**AGENDA
PLANNING AND ZONING BOARD
VILLAGE HALL COUNCIL CHAMBERS
FEBRUARY 8, 2022
6:30 PM**

ITEM #1: Ordinance No. 2022-02 - Land Use Amendment (Small-Scale) - Belmont - 1591 Kirk Road

SUBJECT: Small-Scale Future Land Use Amendment and Residential Plan Development Site Plan with Waivers
Belmont – 1591 Kirk Road

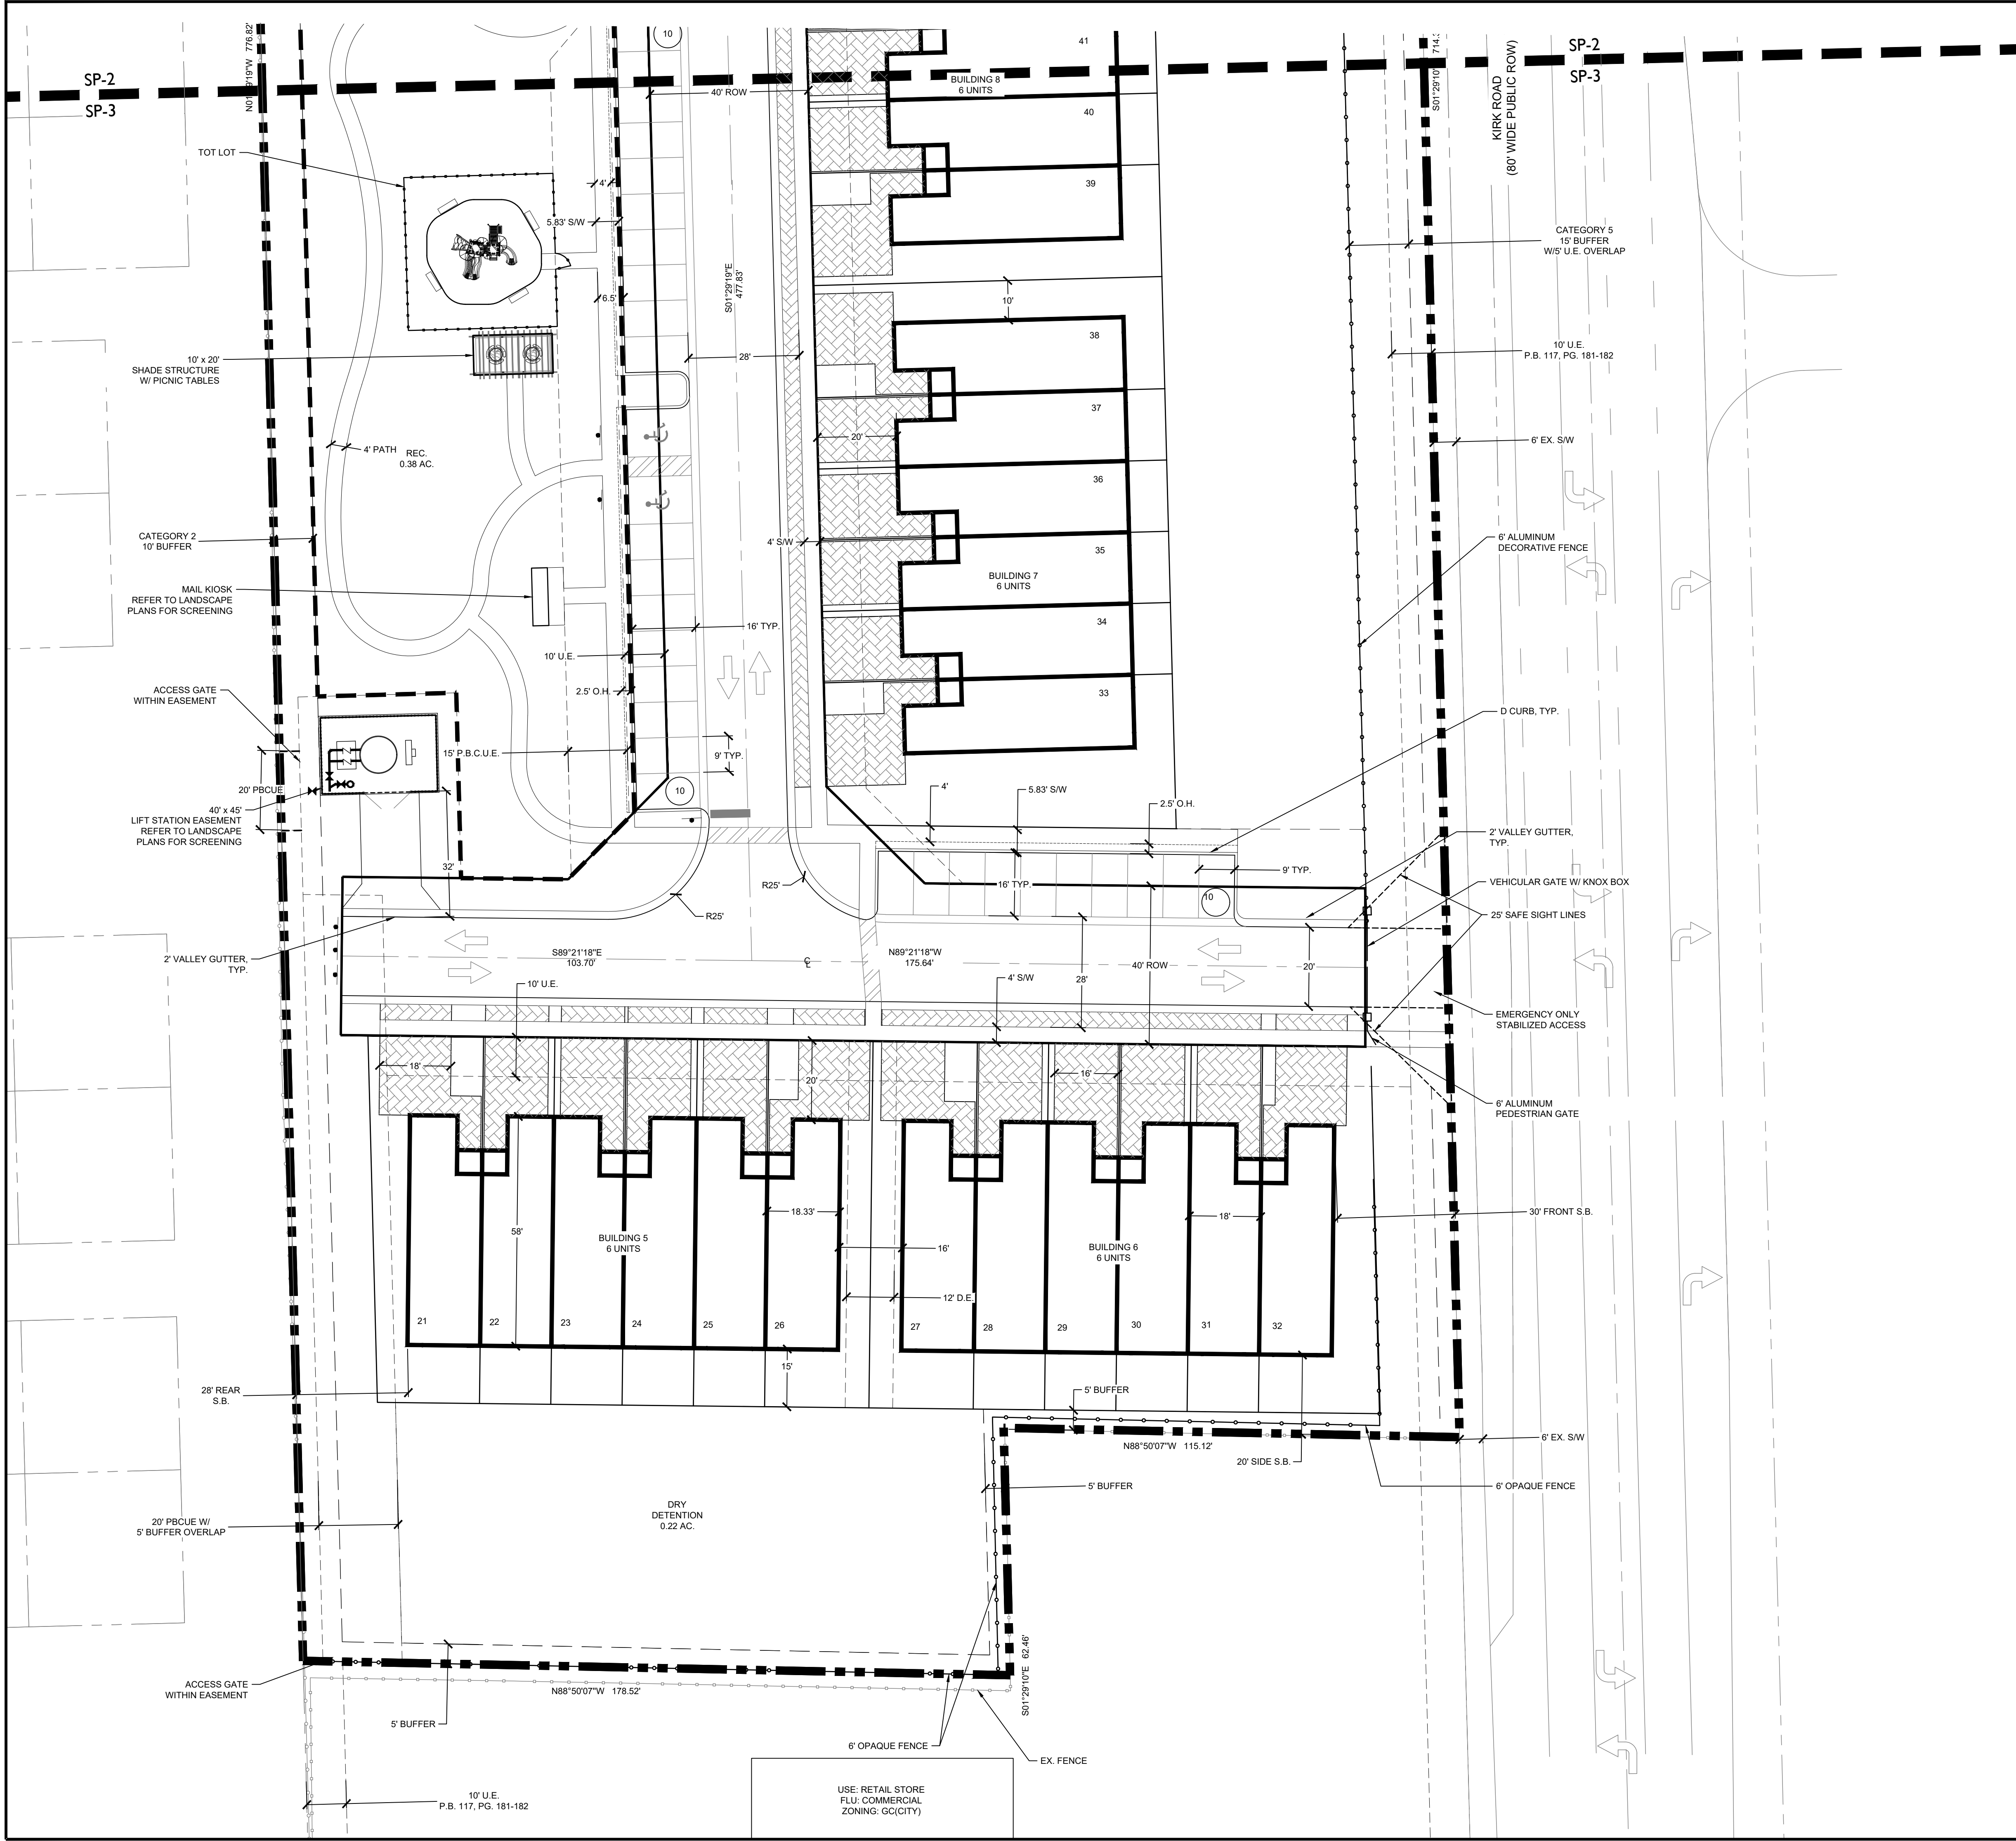
Hi Jerrod,
Per your email **"We're proposing the entrance at the north end of the site, rather than aligned with the school entrance, in order to avoid school traffic and safety concerns"**.
Can you please show driveway/s location on the east side of Kirk Rd on sheet SP-1? Where is the school entrance shown on sheet SP-1?
Bogdan

Hi Jerrod,
Can you please show driveway/s location on the east side of Kirk Rd on sheet SP-1?
I will be on short vacations starting tomorrow and will be back in the office on 8/4.
Bogdan

Applicant Response: The proposed streets are to be privately dedicated and maintained. A note has been added to sheet SP-1.

Applicant Response: For graphic clarity, the utilities and light fixtures have been shown along with the landscape on the landscape plans. Corresponding notes have been added to sheet SP-1.

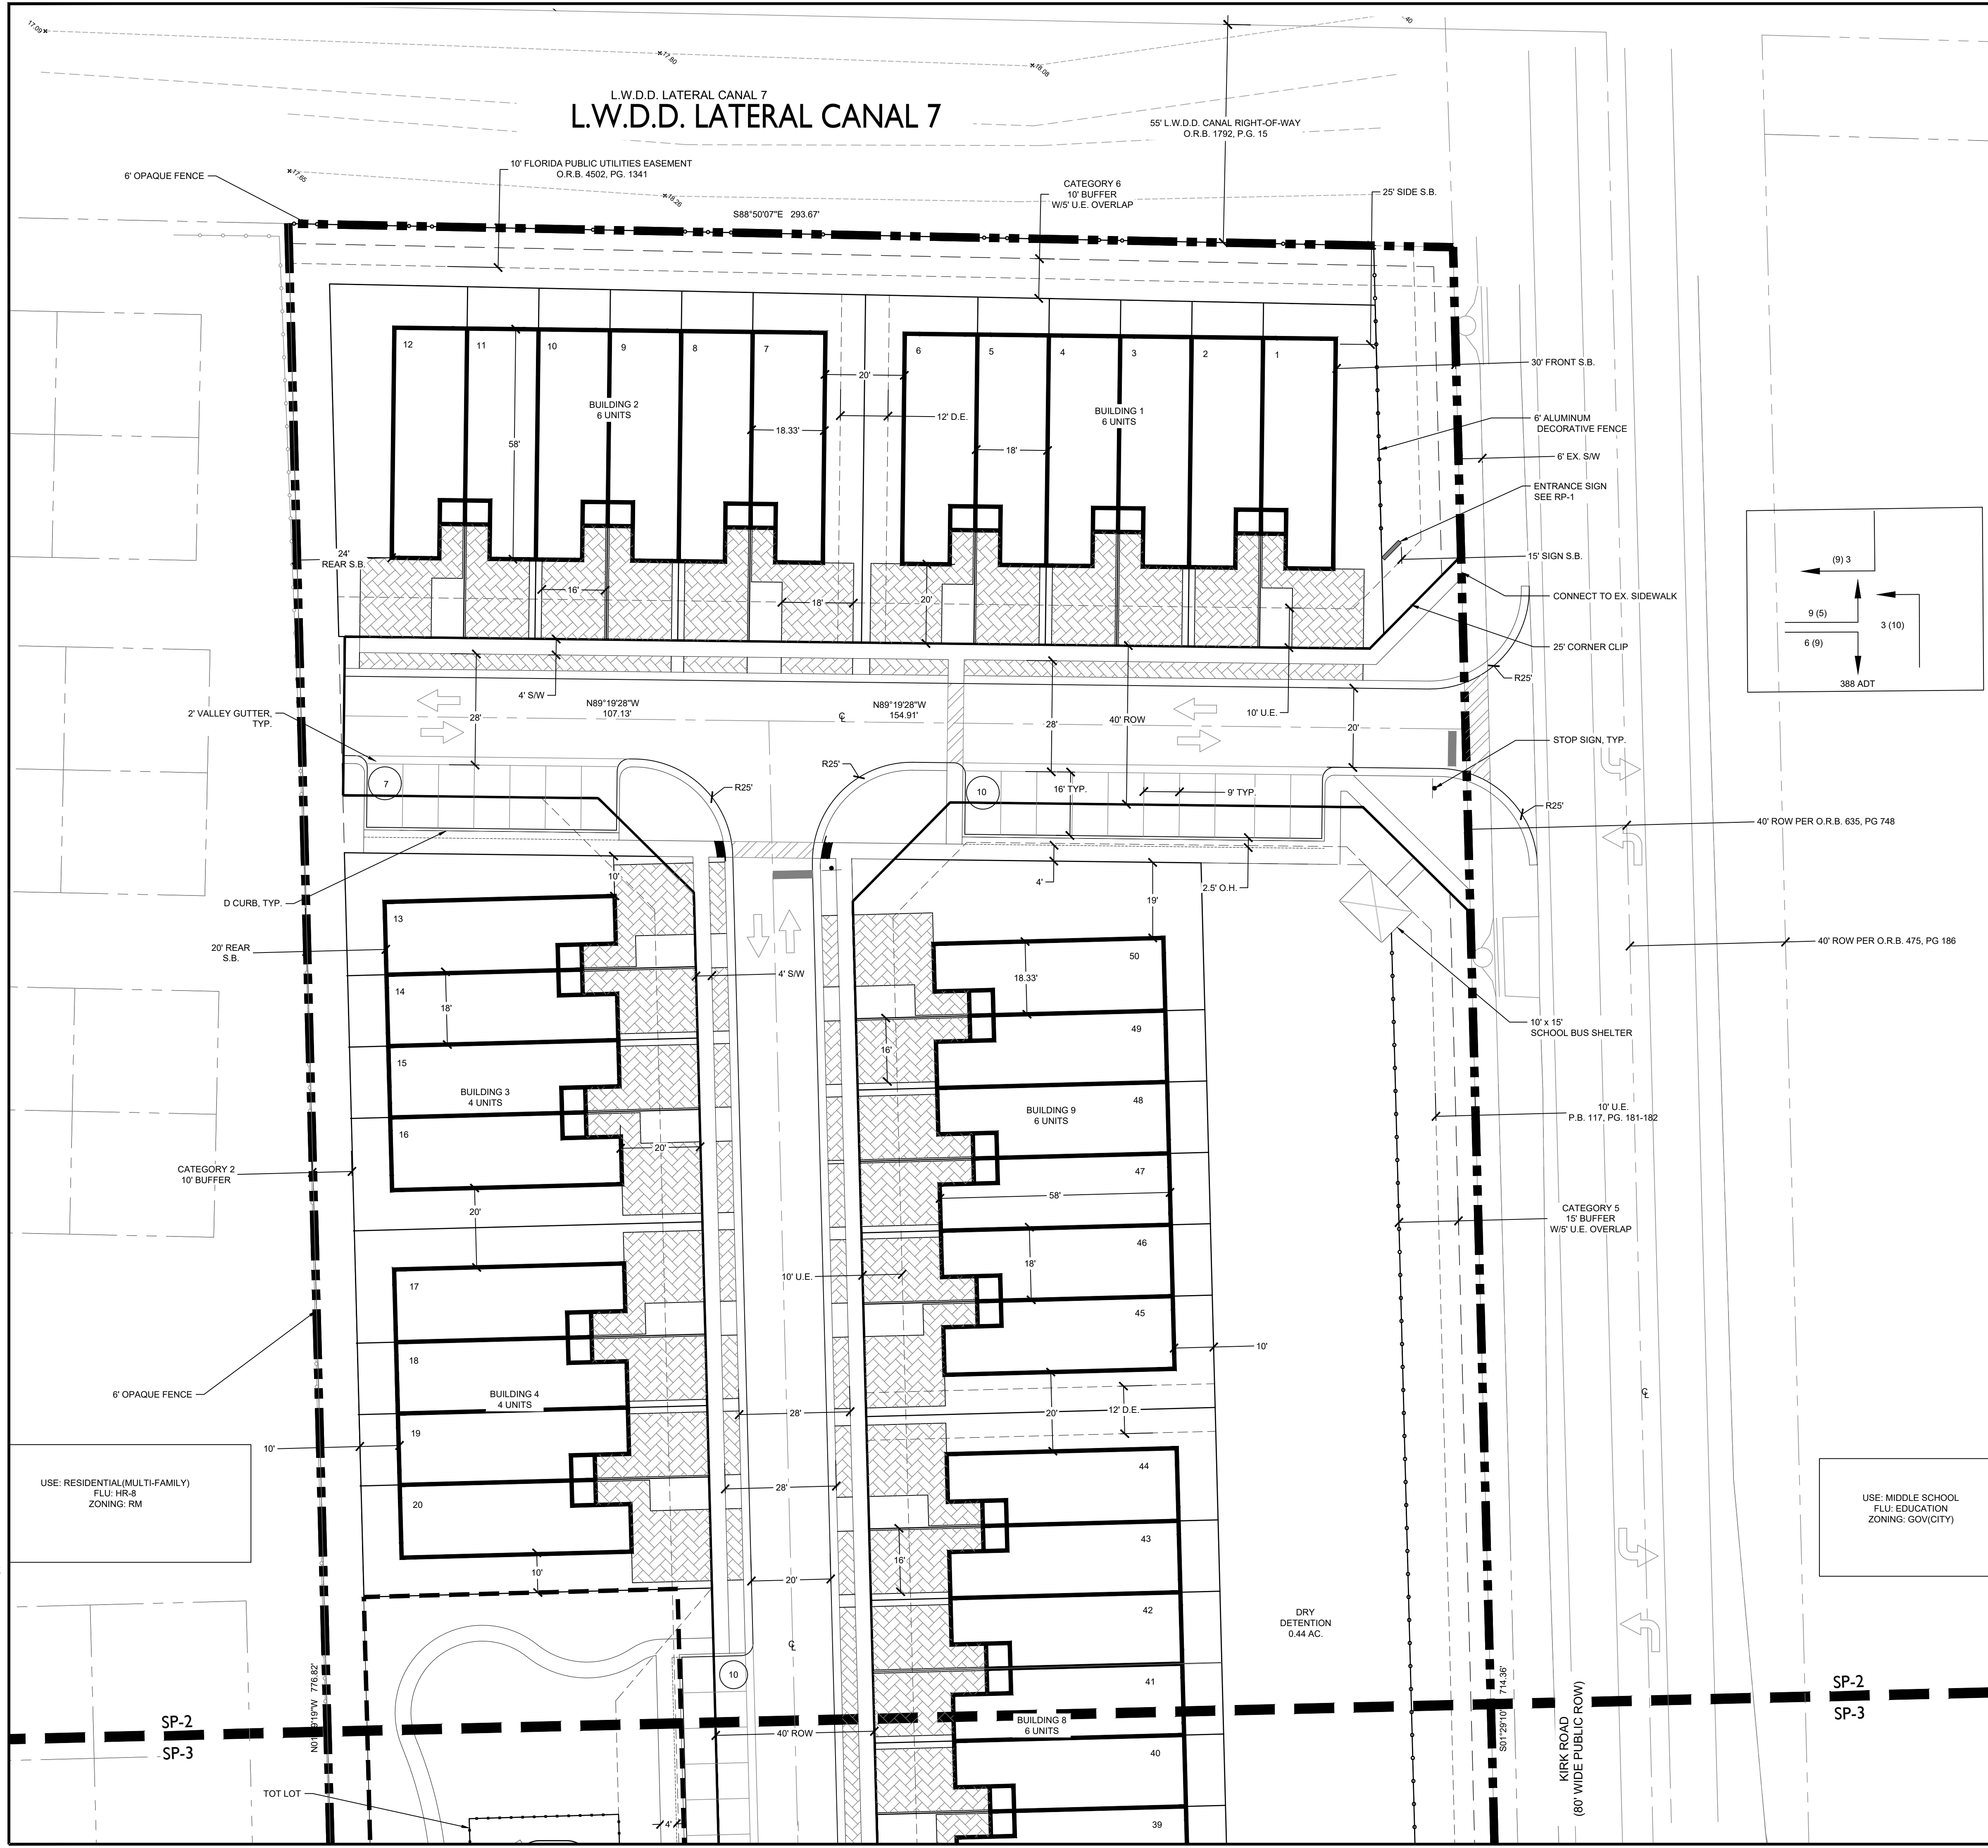
Hi Jerrod,
Per your email **"We're proposing the entrance at the north end of the site, rather than aligned with the school entrance, in order to avoid school traffic and safety concerns"**.
Can you please show driveway/s location on the east side of Kirk Rd on sheet SP-1? Where is the school entrance shown on sheet SP-1?
Bogdan

Hi Jerrod,
Can you please show driveway/s location on the east side of Kirk Rd on sheet SP-1?
I will be on short vacations starting tomorrow and will be back in the office on 8/4.
Bogdan

Applicant Response: The proposed streets are to be privately dedicated and maintained. A note has been added to sheet SP-1.

Applicant Response: For graphic clarity, the utilities and light fixtures have been shown along with the landscape on the landscape plans. Corresponding notes have been added to sheet SP-1.
